PIC16C67 Rev. A Silicon Errata Sheet

The PIC16C67 (Rev. A) parts you have received conform functionally to the Device Data Sheet (DS30234D), except for the anomalies described below.

Clarifications/Corrections to the Data Sheet:

FIGURE 1: WRITES TO TIMER1 (EXTERNAL CLOCK/OSCILLATOR MODE)

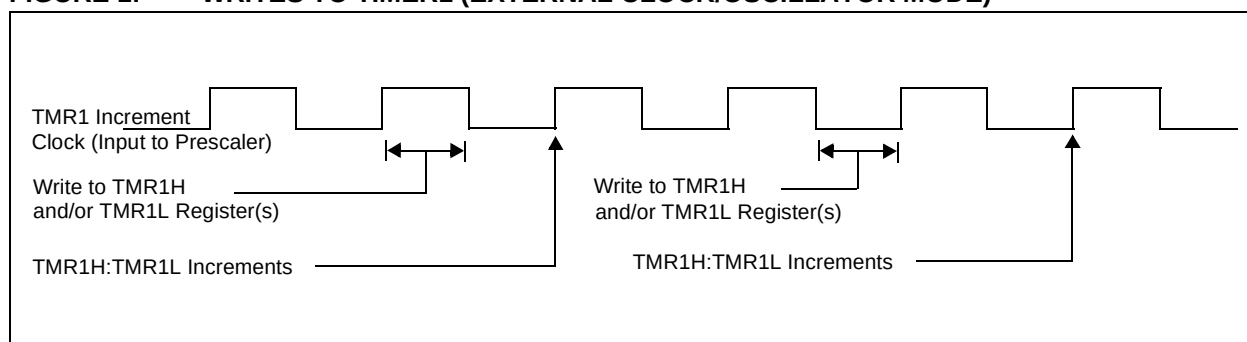
The operation of Timer1 needs some clarification when the timer registers are written and the TMR1ON bit is set.

The internal clock signal, that is the input to the TMR1 prescaler, affects the incrementing of Timer1 (TMR1H:TMR1L registers and the Timer1 prescaler). When the Timer1 registers are NOT written, the Timer1 will increment on the rising edge of the TMR1 increment clock.

When the TMR1H and/or TMR1L registers are written while this clock is high, TMR1 will increment on the next rising edge of this clock.

When the TMR1H and/or TMR1L registers are written while this clock is low, TMR1 will not increment on the next rising edge of this clock, but must first have a falling clock and the rising clock for TMR1 to increment.

Figure 1 shows the two cases of writes to the TMR1H and/or TMR1L registers. Due to the V_{IH} and V_{IL} thresholds on the oscillator/clock pins, external Timer1 oscillator components, and external clock frequency, the Timer1 increment clock may not be of a 50% duty cycle.

The TMR1 increment clock is out of phase of the T1OSO/T1CKI pin by a small propagation delay.
